UNITED STATES PATENT AND TRADEMARK OFFICE

Office Action Summary

10/606,270

Final Rejection

FIG. 4

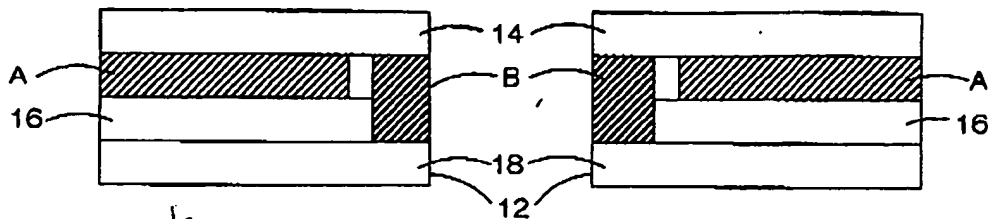
1. New corrected drawings in compliance with 37 CFR 1.121(d) are required in this application because newly submitted drawings Figs 4 and 5 are not accepted for two reasons: (1) it contains new matter as described in following “new matter” rejection, (2) The drawings are objected to under 37 CFR 1.83(a). The drawings must show every feature of the invention specified in the claims. Therefore, the “another layer having a shape that is substantially the same as that of the transparent substrate” must be shown or the feature(s) canceled from the claim(s). No new matter should be entered.

Do not enter it.
Chen 02/03/06

FIG. 5

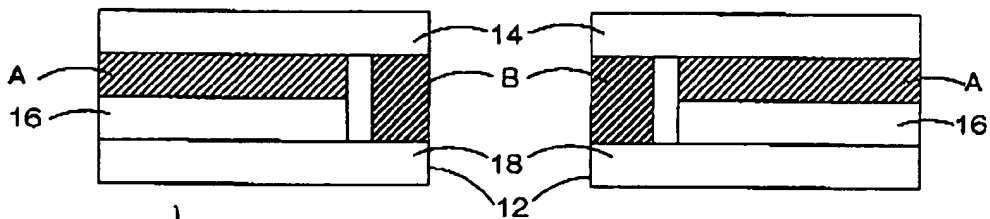
Do not enter it.
Chen 02/03/06
